Water Right Conditions
Tracking Slip

PUBLIC INTEREST REVIEW FOR GROUND WATER APPLICATIONS

SUBJECT: Application G- 17624 Supersedes review of _____
Date of Review(s)

A. GENERAL INFORMATION: Applicant's Name: Willamette Egg Farm County: Clackamas

Application G-17624, Willamette Egg Farm, Gordon Satrum

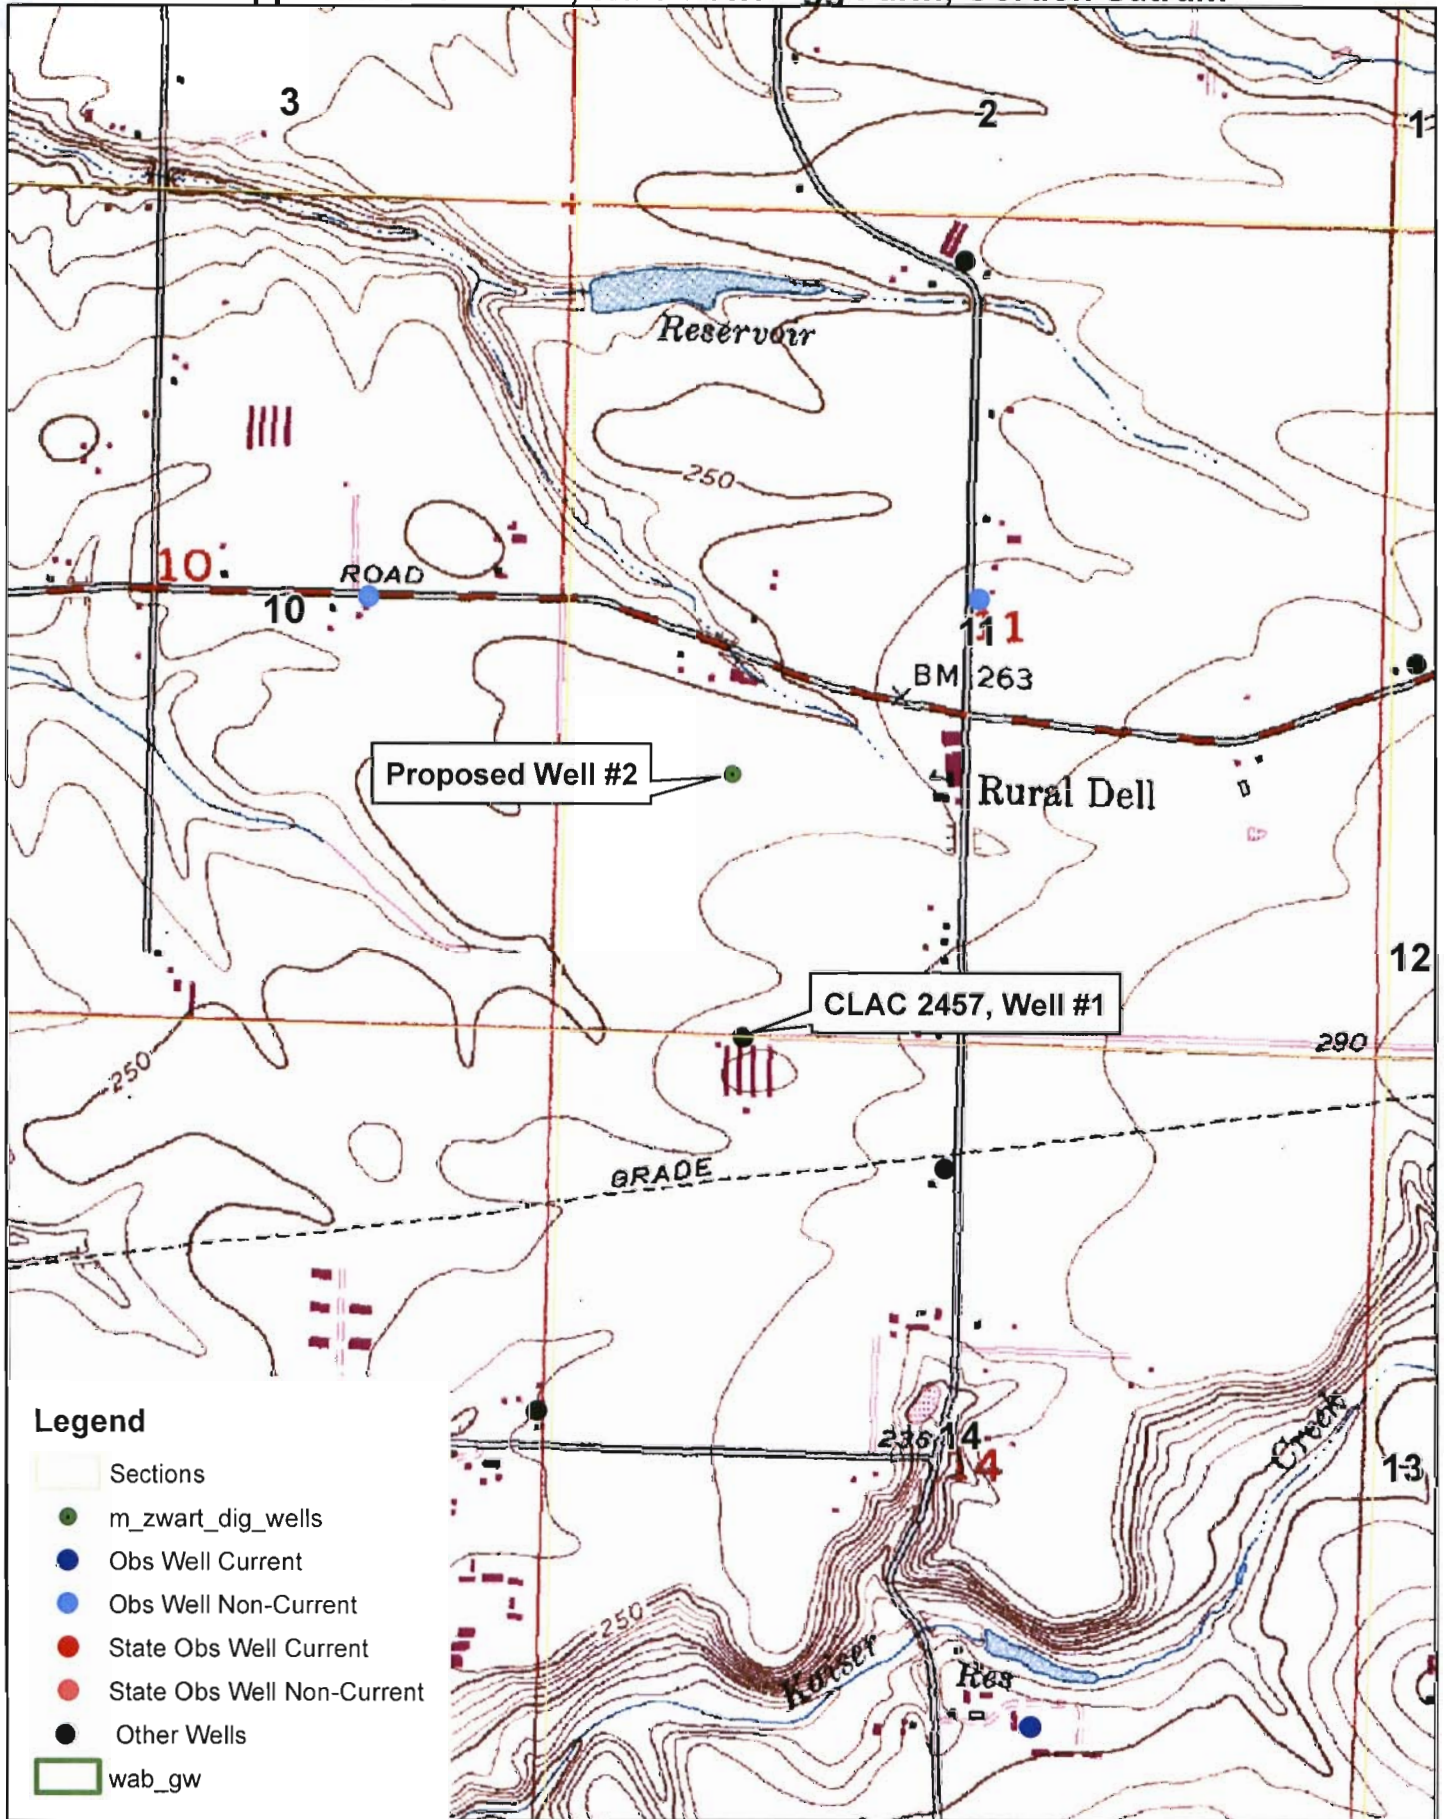
A4. **Comments: The proposed well will be constructed similarly to the existing well. The application may have a conflict with GR-1559, which authorizes a well that develops the same aquifer (CLAC 2468). This application is identical to application LL-1444.**

Basis for aquifer confinement evaluation: Groundwater in the area is confined by the saturated, fine-grained deposits found at the surface, and by the thick intervening clay beds that contain the more productive sand and gravel lenses.

Basis for aquifer hydraulic connection evaluation: Heads in the alluvial aquifer are generally above the elevation of nearby surface water sources, so it is likely that groundwater in the alluvium is discharging to nearby streams. Bear Creek also drops below 200 feet within a short distance downstream. Water table maps in the area (Woodward and others, 1998) also indicate that ground water in the alluvial aquifer is discharging to surface water sources in the area.
